Subject: 2018-0211 – Mactung Class 4 Quartz Exploration – Responses to Information Requests

**MACTUNG
QUARTZ MINING LAND USE APPROVAL**

Site Plan

Figure IR-1

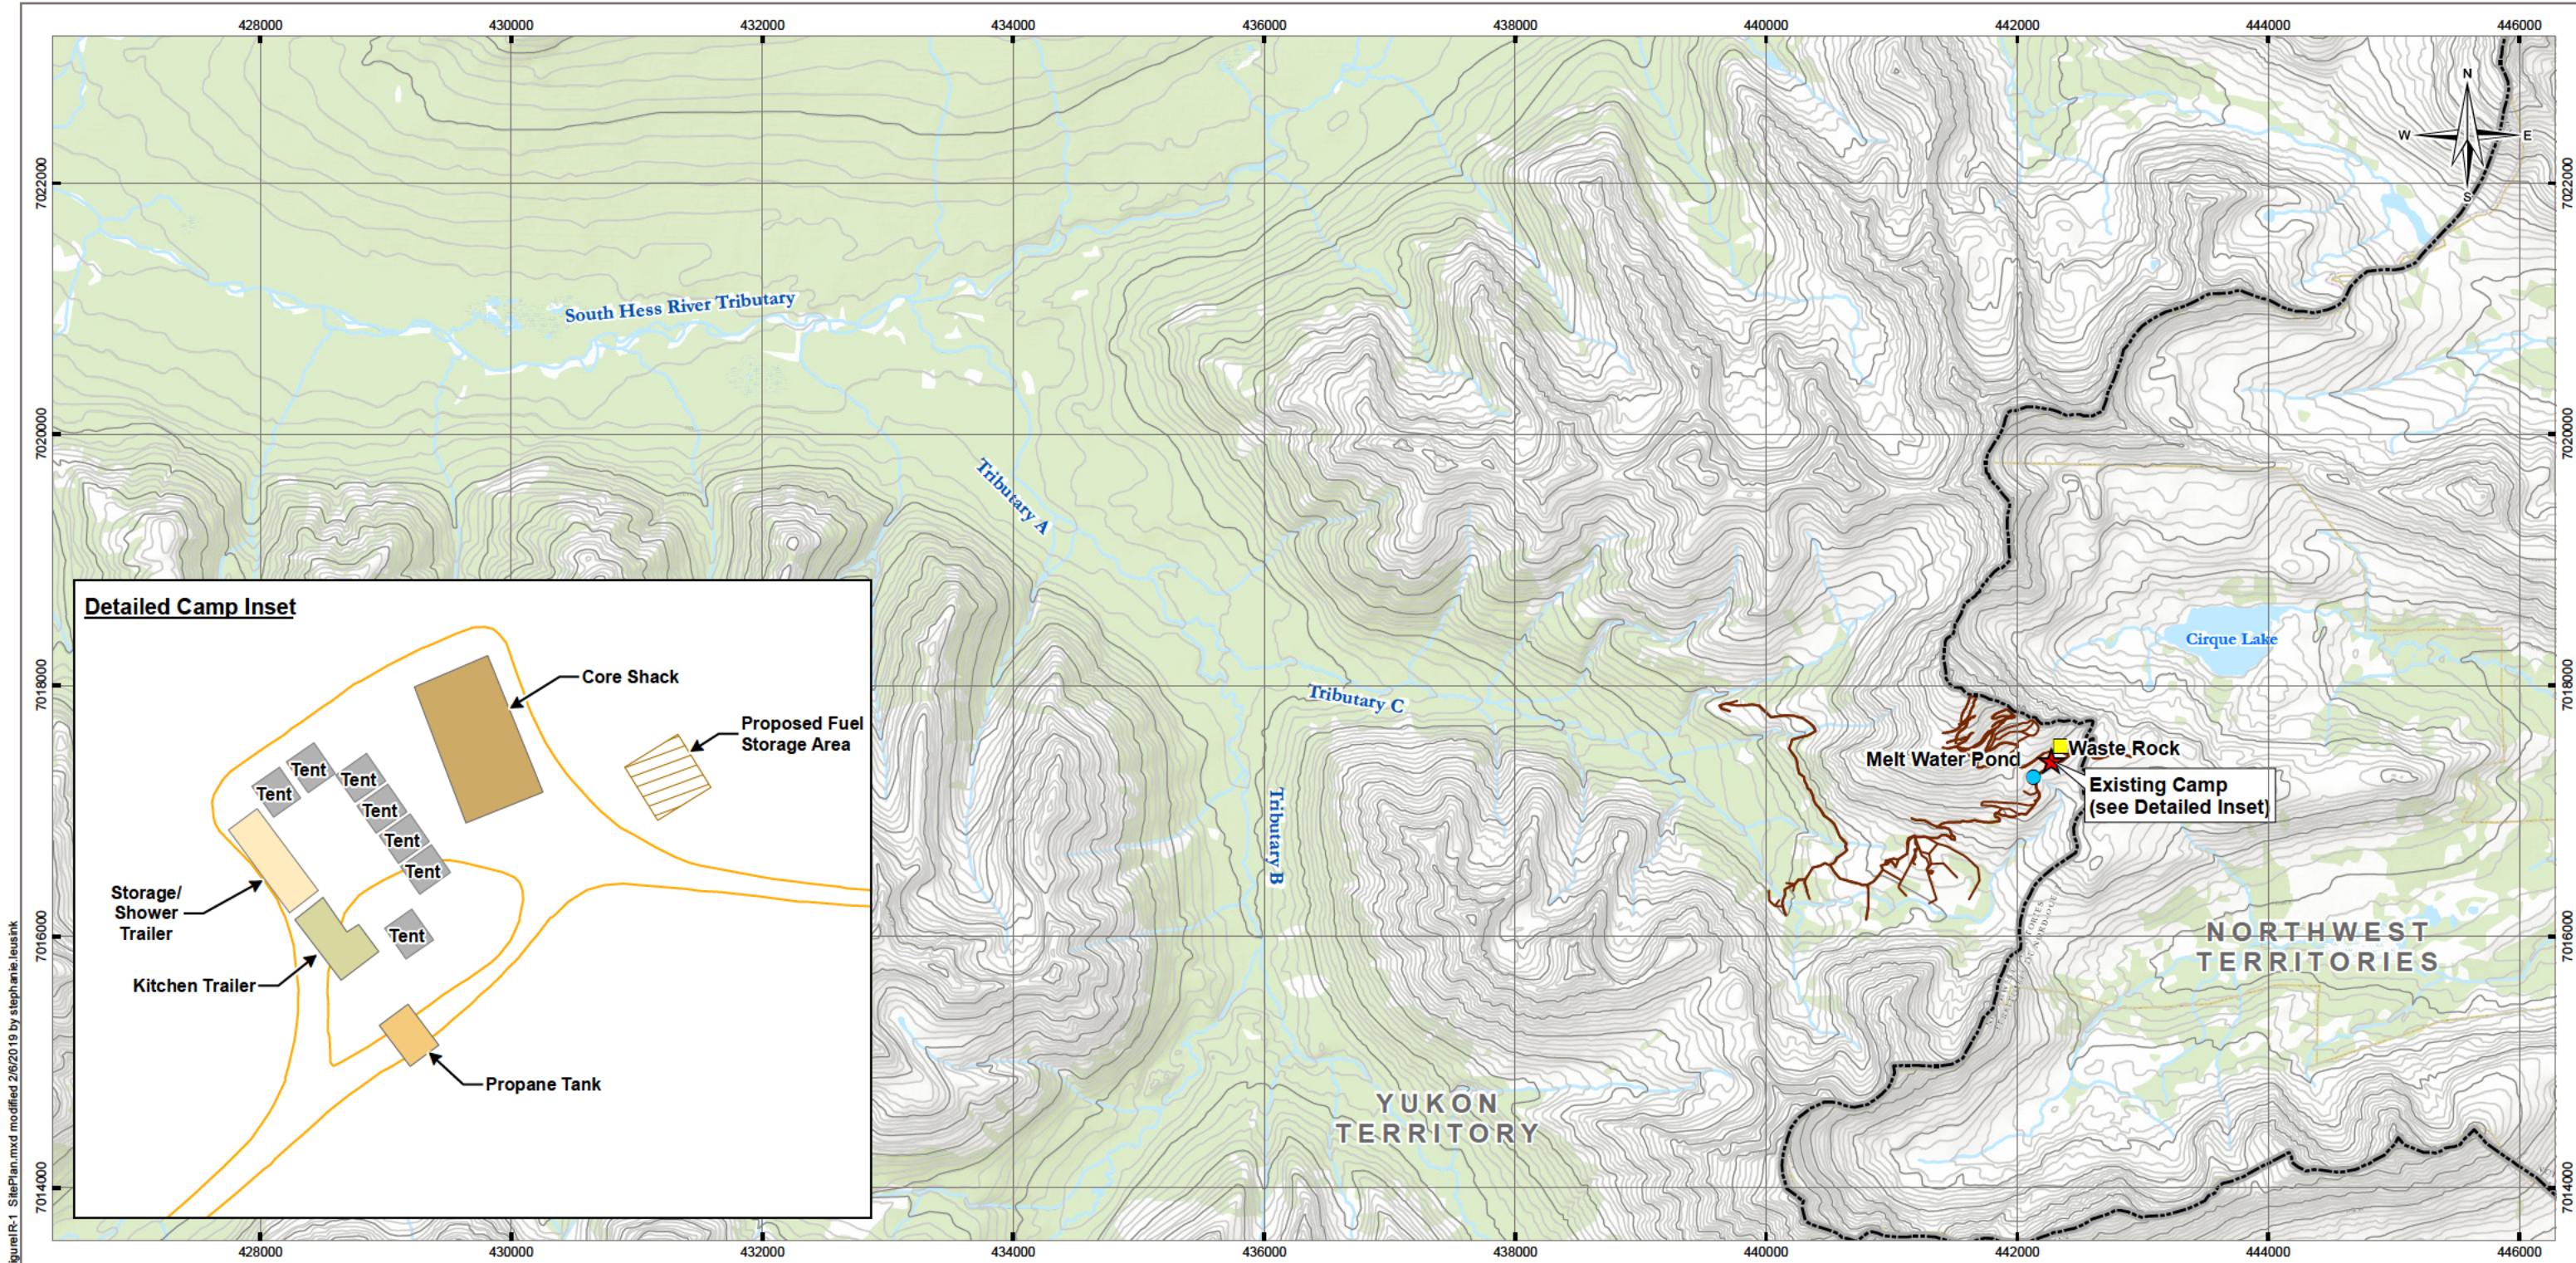
- b. Maps have been provided showing the existing roads/trails and camp location. Please describe other existing infrastructure that is in place (underground workings, buildings, heli-pads, etc.) and provide a map showing locations of the infrastructure.

10. Please confirm our understanding that the only fuel storage to occur on site for the duration of project (10-year) activities is 3 785 L (1 000 US gal) of propane.

In addition to the camp, the latest site inspection report from September 2018 identified the presence of two Atco trailers, a wood enclosed building, storage building, bulk propane tank, core storage area and meteorological station (all within approximately 100 m of the camp). An existing exploration adit is also present with limited underground workings. A lined sump is also present near the portal. The site is located above the treeline so the construction of formal heli-pads or vegetation clearing for such purposes has not been required. Figure IR-1 shows the approximate location of the infrastructure described above.

In addition to the amount of propane identified, it is anticipated that approximately 50 barrels of fuel will be stored on-site at any one time, with a plan to resupply through Ross River (our apologies – this should have been included as part of the MLUA). Barrels will be stored in a lined, bermed facility near the existing camp that will be constructed prior to the barrels arriving at site. Fuel will be stored a minimum of 30 m away from the nearest waterbody. The approximate location of the proposed fuel storage area is shown on Figure IR-1.
